**APPLICATION FOR PERMISSION
UNDER SECTION 16 OF
THE TOWN PLANNING ORDINANCE
(CAP. 131)**

寄件者: 陳灝然 [REDACTED]
寄件日期: 2025年01月22日星期三 16:33
收件者: tpbpd/PLAND
副本: Wilfred Ka Hing CHU/PLAND
主旨: A/YL-LFS/548補充資料
附件: Form No. S.16-III_Sep 2023.pdf; 填土位置圖.pdf; 場地設計圖.pdf; 申請理由.pdf
類別: Internet Email

A/YL-LFS/548

Various Lots in D.D. 129 and Adjoining Government Land, Ngau Hom Tsuen, Lau Fau Shan

填土位置圖

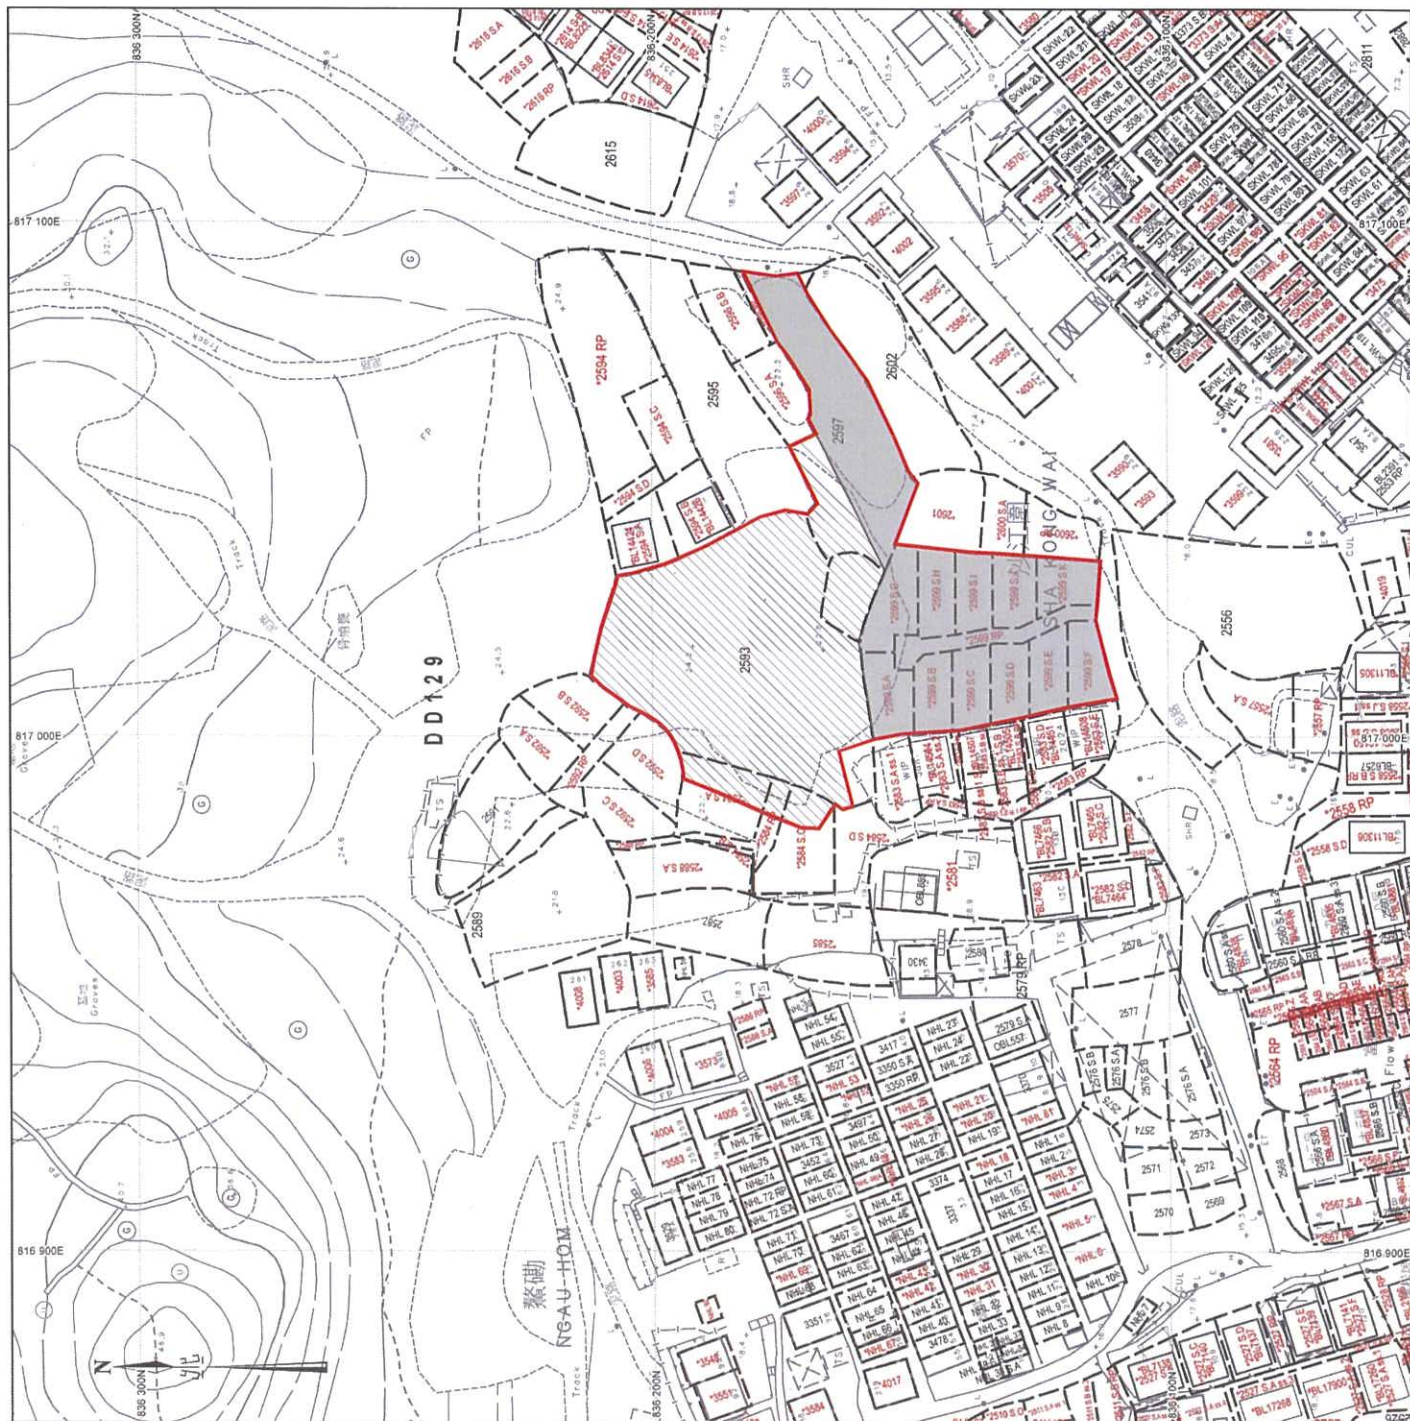
在填土方面，填土位置面積約 2170 平方米，填土厚度約 0.2 米，填土物料為混凝土及泥土，即設計圖中灰色陰影地帶，位於場地東面及南面。（可參閱：填土位置圖）

另外，有約 2426 平方米是不需要填土的，即設計圖中斜線範圍，因其幾年前已是混凝土及泥地，申請人希望把填土工程申請規範化，即此申請地點的北面。（可參閱：填土位置圖）

PART COPY OF FRESH WATER MAINS RECORD PLAN(S)

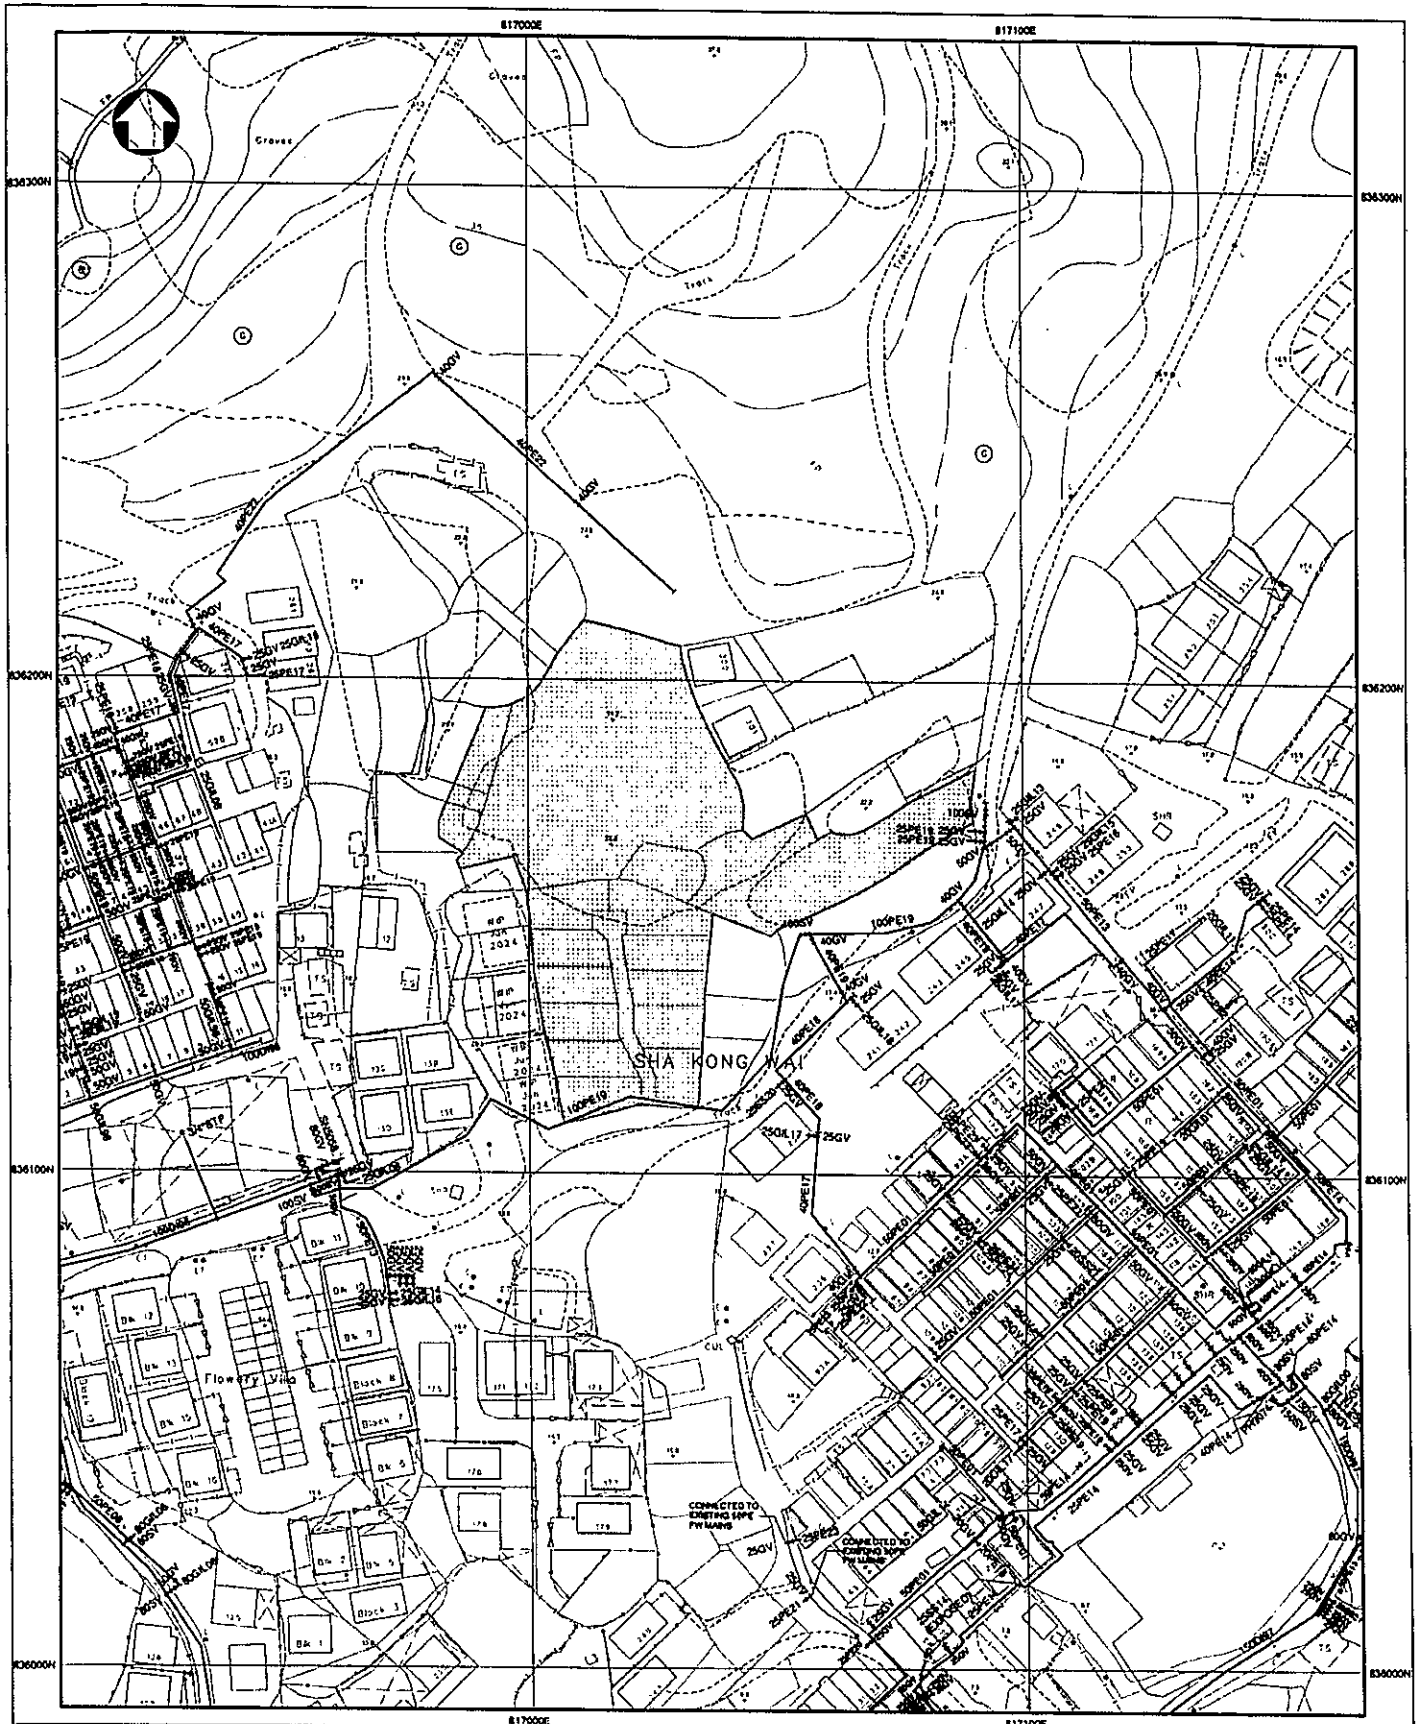
- (f) to note the comments of Chief Engineer/Construction, Water Supplies Department (CE/C, WSD) that:
 - (i) existing water mains will be affected as shown on the plan (**Appendix VI**). The cost of any necessary diversion shall be borne by the proposed development;

- (ii) in case it is not feasible to divert the affected water mains, a waterworks reserve within 1.5 metres from the center line of the water main shall be provided to WSD. No structure shall be built or materials stored within this waterworks reserve. Free access shall be made available at all times for staff of the Director of Water Supplies or their contractor to carry out construction, inspection, operation, maintenance and repair works;

- (iii) no trees or shrubs with penetrating roots may be planted within the Waterworks Reserve

or in the vicinity of the water main as shown on the plan (**Appendix VI**); and
